UNITED STATES PATENT AND TRADEMARK OFFICE

APPLICATION NO.	FILING DATE	FIRST NAMED INVENTOR	ATTORNEY DOCKET NO.	CONFIRMATION NO.
10/767,212	01/28/2004	Frederick J. Dojan	005127.00277	2583

Office Action Summary

DETAILED ACTION

FIG. 1

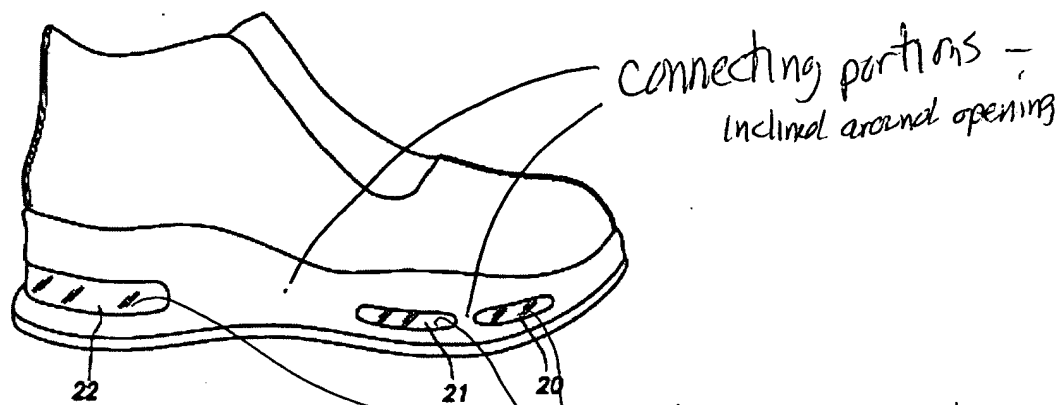
Pavone teaches a sole component as claimed including a bladder and a reinforcing structure at least partially recessed into the barrier material as claimed. See the marked-up figures below.

Pavone teaches a sole component as claimed (as noted above) except for the modulus of elasticity of the materials as claimed (claim 16) and portions of the reinforcing structure being in tension (claim 16 and 25). Pavone is silent with regard to the modulus of elasticity. However, it is conventional and well known in the art for bladder to have a lower modulus of elasticity than the structure enclosing the bladders. Bladders have a lower module of elasticity inasmuch as bladders in the footwear art provide a cushioning effect for the wearer. Therefore, it would have been obvious to provide the reinforcing structure of Pavone with a greater modulus elasticity than barrier material of the bladder.
